Ref No.: PM:VCB:OHKit:BJN:03 **Dated:** 20.02.2026

Subject: Submission of AOH/IOH/POH kit for Autometers Alliance Ltd. make VCB fitted with M/s CKD make PRV.

Annexure A

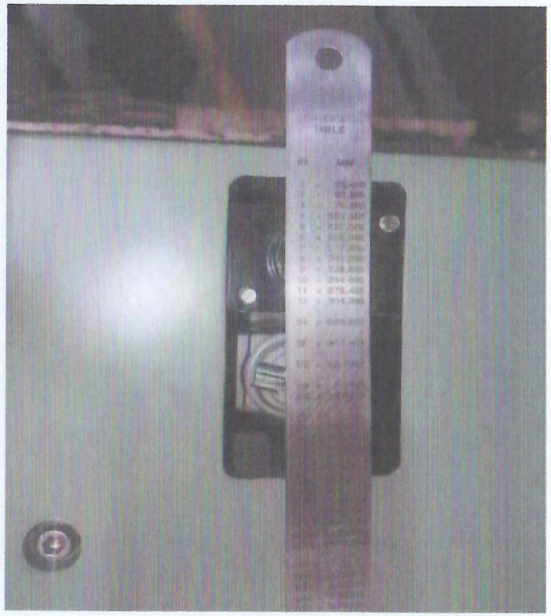
1. As requested in our letter referred at S.No.3 above, regarding the use of CKD Model W2000-10G-W-FLA98253 Pressure Regulator in place of CKD Model W2000-10-M1, we have once again made a detailed study on the same and it is seen that when the CKD Model W2000-10-M1 is fitted in the VCB, the exhaust knob is projected outside the protection cover of the VCB whereas, the CKD Model W2000-10G-W-FLA98253 when fitted is well inside the protection cover of the VCB. It may be noted that there are chances of damage to the Pressure regulator if it is protruding out of the protection cover of the VCB. Photograph of VCB's with fitted with both the CKD models is attached alongwith for your kind reference (Annexure A). Also, please find attached the letter dated 19.08.2025 from the authorized distributors of CKD India Ltd., that the working of both the models is the same and the only difference is in the threading. Copy of the letter is also attached alongwith at Annexure B. In view of the above, we have modified the Overhauling kits accordingly.

AAL VCB with PRV CKD Model – W2000-10-M1

Exhaust knob projected outside the protection cover

AAL VCB with PRV CKD Model – W2000-10G-W-FLA98253

Exhaust knob NOT projected outside the protection cover
